APPEAL SUMMARY

Appeal ID: 24514	Project Address: 3818 N Vancouver Ave
Hearing Date: 1/13/21	Appellant Name: Doug Skidmore
Case No.: B-003	Appellant Phone: 5032226580
Appeal Type: Building	Plans Examiner/Inspector: Roza Malekzadeh
Project Type: commercial	Stories: 2 Occupancy: B Construction Type: V-B
Building/Business Name: 3818 N Vancouver	Fire Sprinklers: Yes - throughout
Appeal Involves: Erection of a new structure	LUR or Permit Application No.: 20-172914-CO
Plan Submitted Option: pdf [File 1] [File 2] [File 3] [File 4] [File 5] [File 6] [File 7]	Proposed use: B occupancy professional office building

Appeal item 1

CODE SUMMARY DIAGRAM - EGRESS

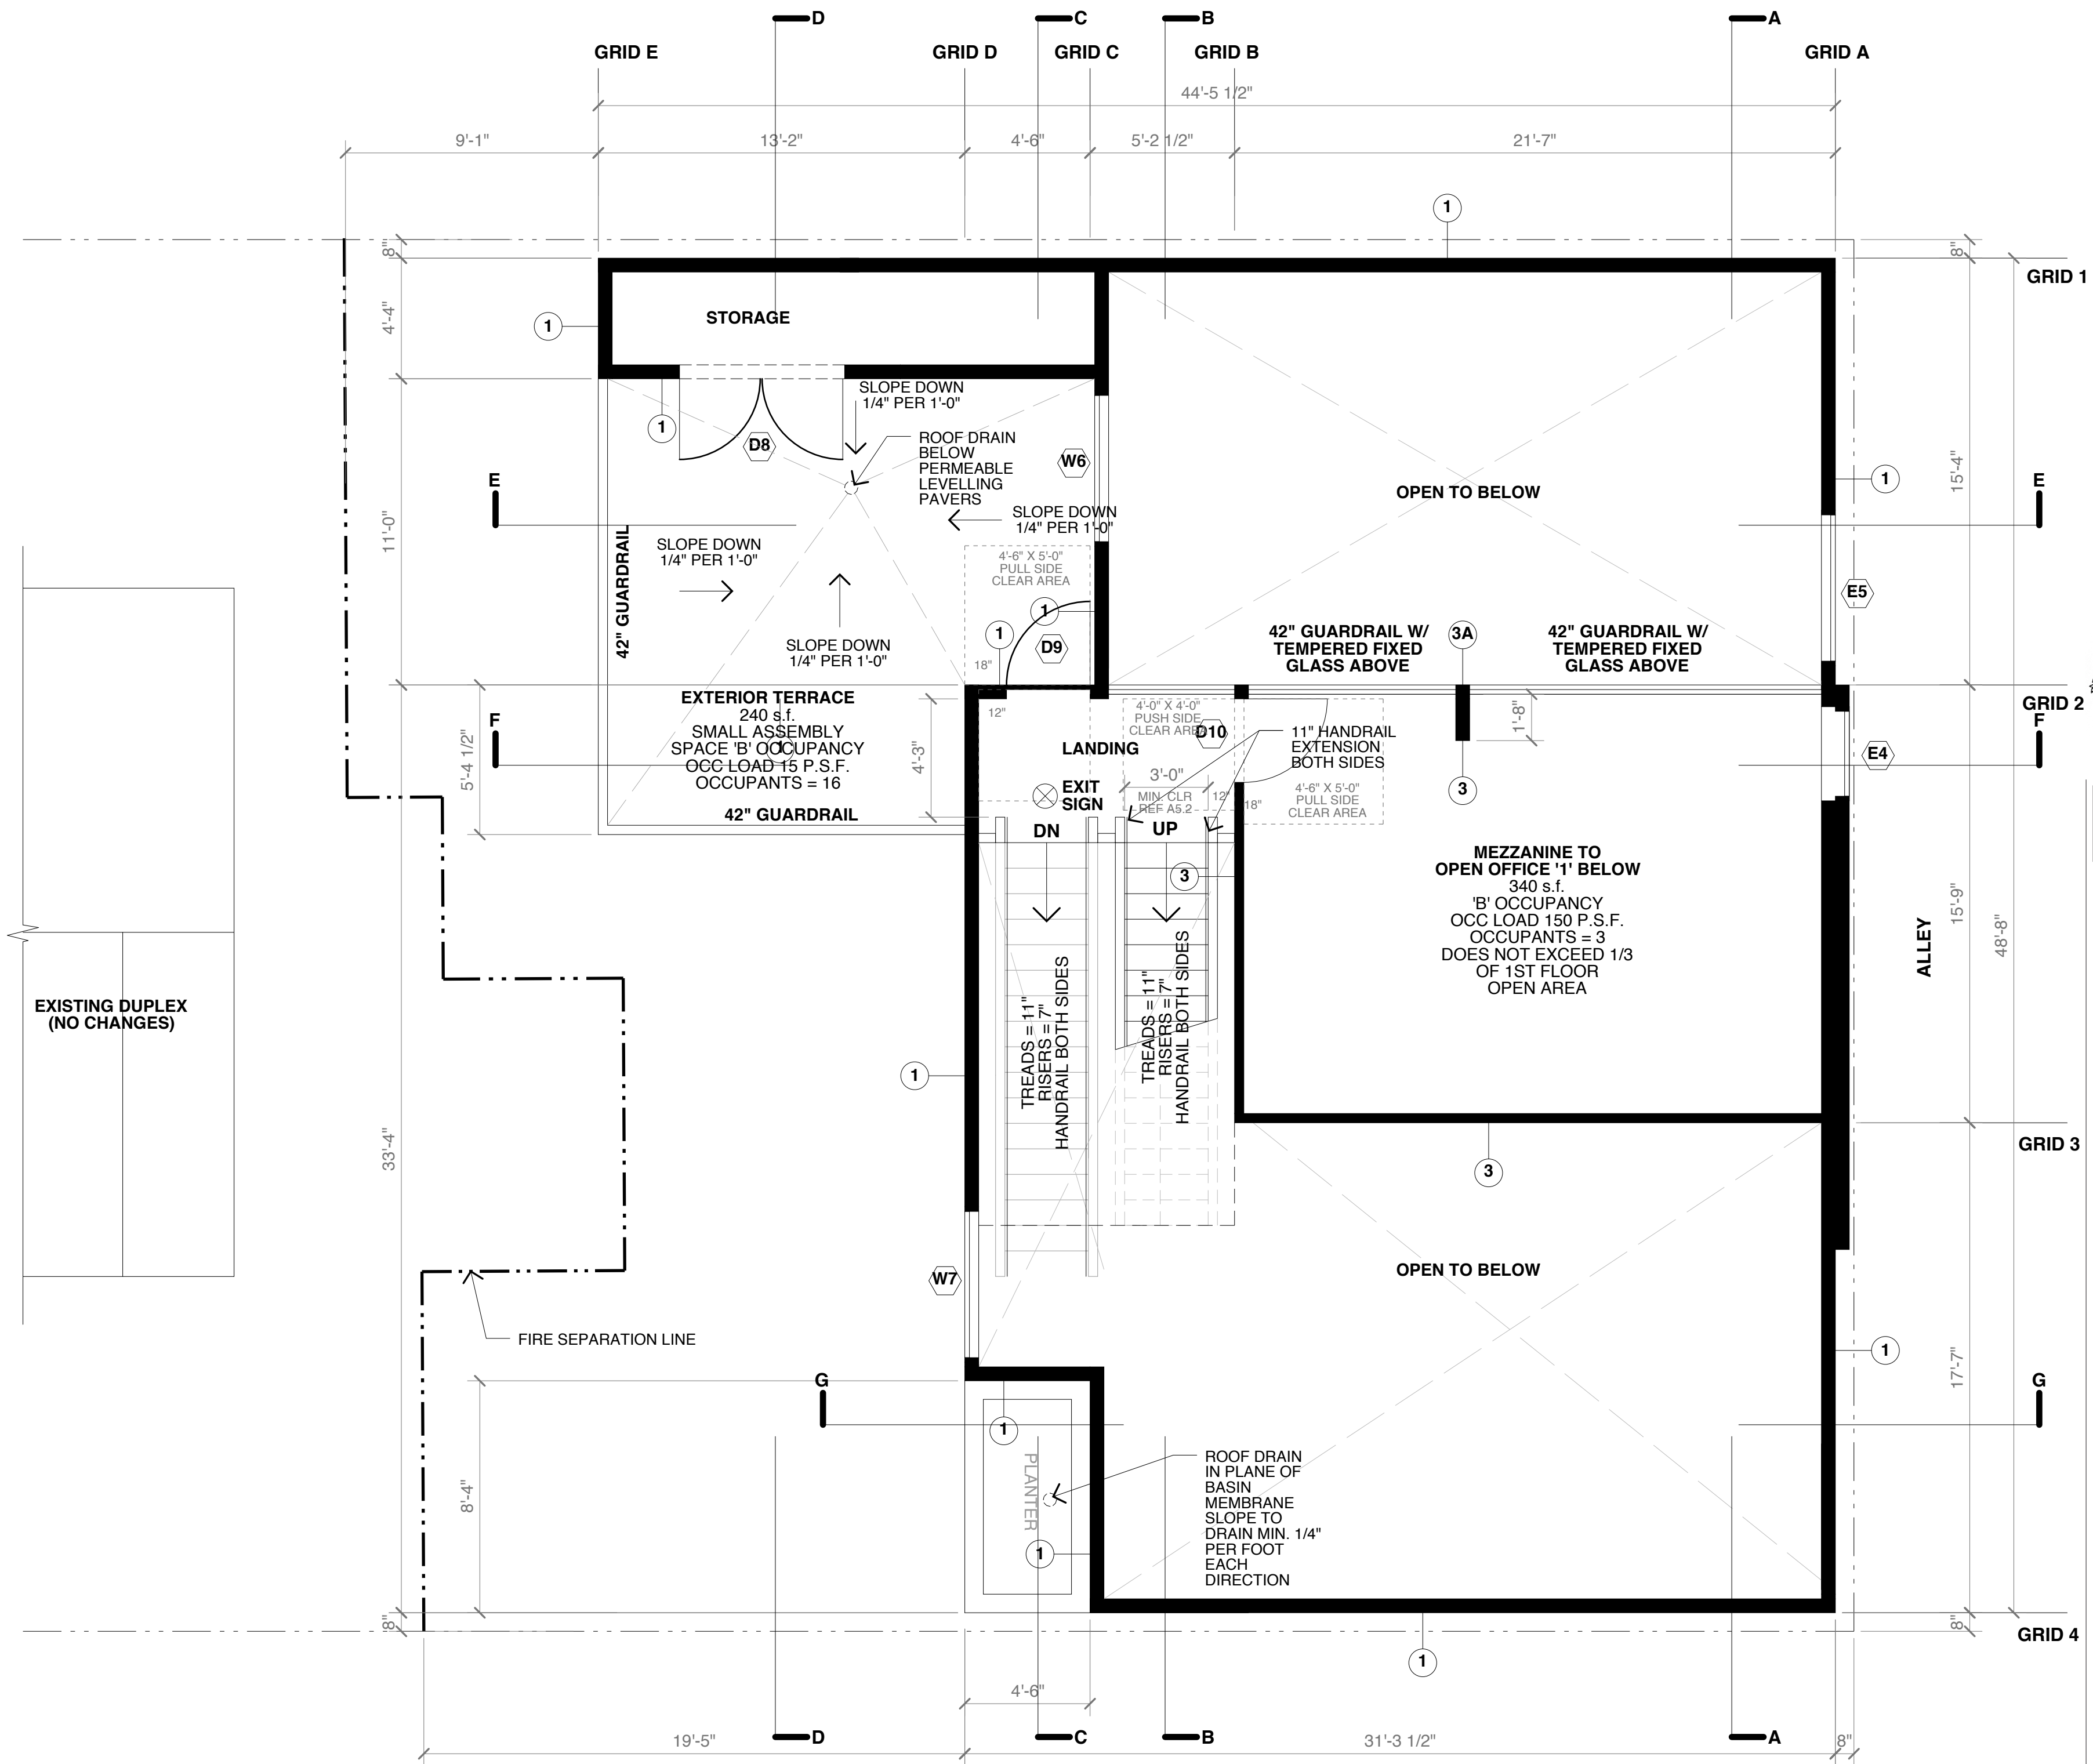
Code Section	Table 1006.3.3(2)
Requires	<p>MAXIMUM TRAVEL DISTANCE TO EXIT ACCESS SHALL NOT EXCEED 75' FOR 'B' OCCUPANCY WHERE THE SECOND STORY MEETS REQUIREMENTS FOR A SINGLE EGRESS ROUTE.</p>
Code Modification or Alternate Requested	<p>APPEAL IS SOUGHT TO INCREASE 1006.3.3(2) EXIT ACCESS TRAVEL DISTANCE BY 59' FOR A COMPACT TWO STORY BUILDING WITH A SMALL FOOTPRINT.</p> <p>EQUIVALENT LIFE SAFETY TO BE PROVIDED BY INSTALLATION OF AN NFPA 13 SPRINKLER SYSTEM THROUGHOUT THE BUILDING. NO EXCEPTION TO THE CRITERIA OF EGRESS FROM THE SECOND STORY IS SOUGHT.</p> <p>THE MAXIMUM TRAVEL DISTANCE TO EXIT ACCESS WOULD BE 134', WITH A SECOND EXIT OPTION AT 126'-6".</p>
Proposed Design	<p>THE PROPOSED BUILDING UTILIZES A SINGLE OPEN STAIRCASE IN COMBINATION WITH A SPRINKLER SYSTEM INSTALLED THROUGHOUT THE BUILDING. THIS STAIR SERVES A RELATIVELY SMALL OCCUPANT LOAD OF 12 FROM ITS UPPERMOST (SECOND) STORY.</p> <p>12 OCCUPANTS IS LESS THAN 1/4 OF THE NUMBER OF OCCUPANTS THAT WOULD NORMALLY BE PERMITTED, BASED ON OCCUPANT LIMIT, FOR A SINGLE MEANS OF EGRESS FROM A STORY OR A SPACE.</p> <p>THE TRAVEL DISTANCE EXCEEDS 75' DUE TO THE NECESSITY OF THE 3-FLIGHT STAIR SYSTEM SERVING BOTH THE FIRST AND SECOND FLOORS AND THEIR RESPECTIVE MEZZANINES.</p>

THE TOTAL TRAVEL DISTANCE FROM THE FURTHEST EXTENT OF THE UPPERMOST MEZZANINE TO THE POINT OF EXIT OFF OF THE SECOND STORY IS 58', WHICH IS SLIGHTLY MORE THAN HALF THE MAXIMUM ALLOWABLE EXIT TRAVEL DISTANCE FOR THAT INDIVIDUAL STORY (100' IN A SPRINKLERED BUILDING). THE REMAINDER OF THE TRAVEL DISTANCE IS DUE TO TRANSVERSING THE STAIRS SERVING THE SECOND STORY AND CROSSING THE FIRST STORY FLOOR PLATE.

THE COMMON PATH OF TRAVEL WITHIN THIS BUILDING IS 99'-6" WHICH IS LESS THAN THE 100' ALLOWABLE. (THE BUILDING DOES NOT EXCEED C.P.T. LIMITS IN ANY WAY).

TWO OF THE GROUND FLOOR EXITS ARE A "STRAIGHT SHOT" FROM THE BOTTOM OF THE OPEN STAIR. ONE OF THESE EXITS IS 27' FROM THE BOTTOM OF THE OPEN STAIR, AND THE OTHER EXIT IS 34' FROM THE BOTTOM OF THE OPEN STAIR, SO THAT THE FINAL TRAVEL SEGMENT ACROSS THE FIRST FLOOR PLATE IS LESS THAN THE OVERALL INCREASE SOUGHT.

Increase maximum allowable common path of travel from 75 feet to 127 feet: Hold for additional information.
